# UNITED STATES PATENT AND TRADEMARK OFFICE

APPLICATION NO.	FILING DATE	FIRST NAMED INVENTOR	ATTORNEY DOCKET NO.	CONFIRMATION NO.
10/628,790	07/28/2003	Quan-Chiu Harry Lam	HSJ920030043US2(HITG.052P	5213

<b>Office Action Summary</b>	<b>Application No.</b> 10/628,790	<b>Applicant(s)</b> LAM, QUAN-CHIU HARRY	
	<b>Examiner</b> A. J. HEINZ	<b>Art Unit</b> 2653

Addendum A

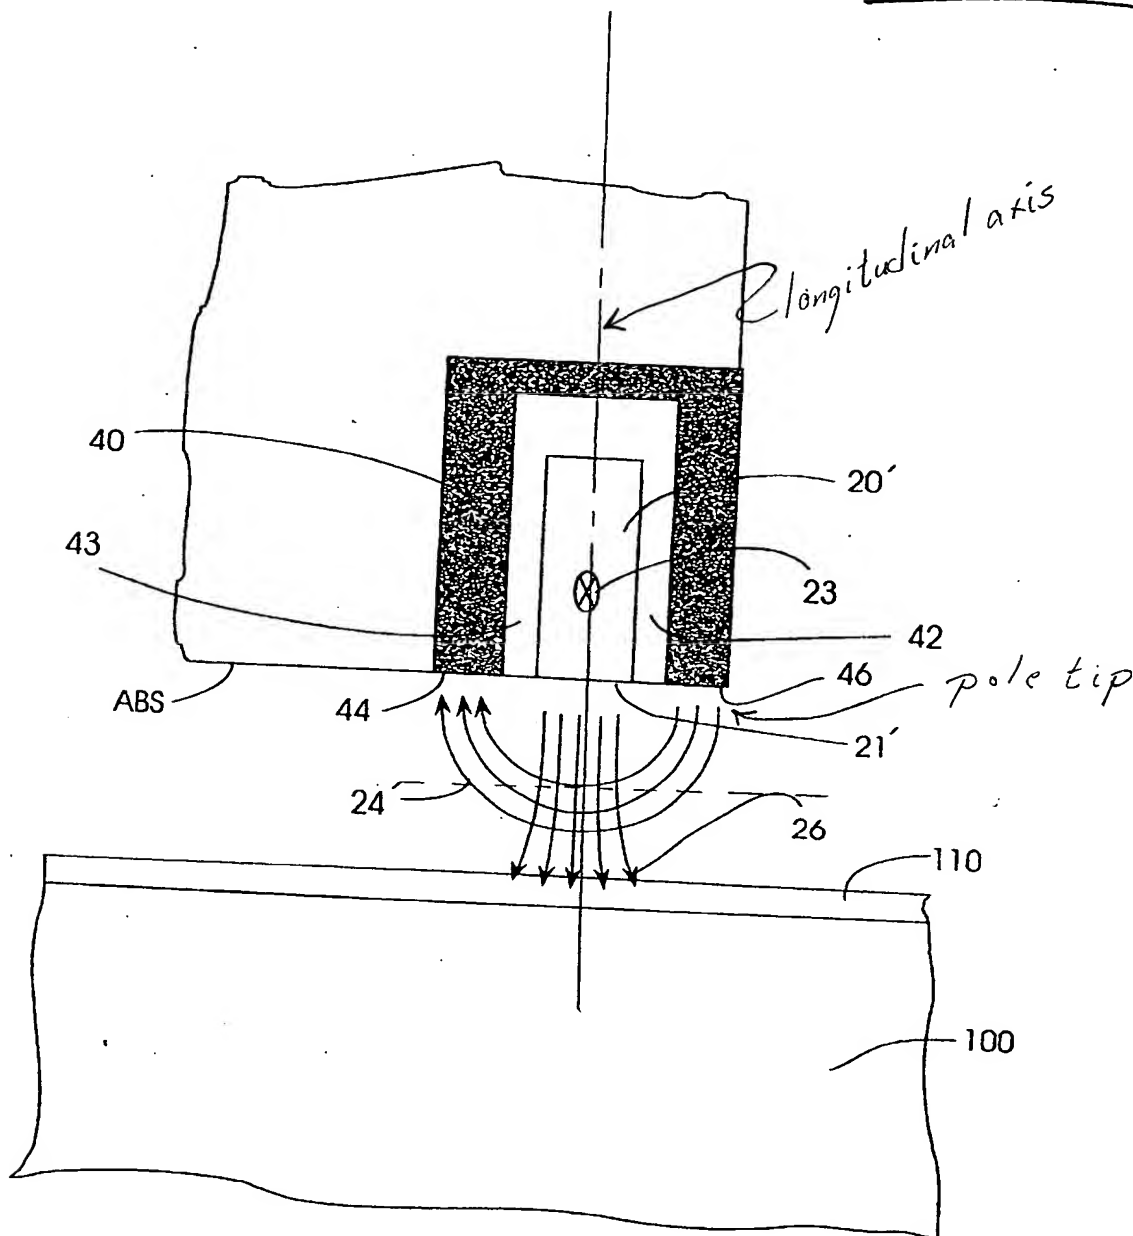
3. Claims 1-11,13-23,25-27,29&30 are rejected under 35 U.S.C. §102(e) as being anticipated by Hsu.

See Fig. 4. Note, to the extent claimed and understood, the structure as shown in Addendum A reads on and performs to the same degree as claimed. The magnetic field (24') generated by bias source 20' at the air bearing surface of the pole tip 46 is substantially transverse to the longitudinal axis of the head.
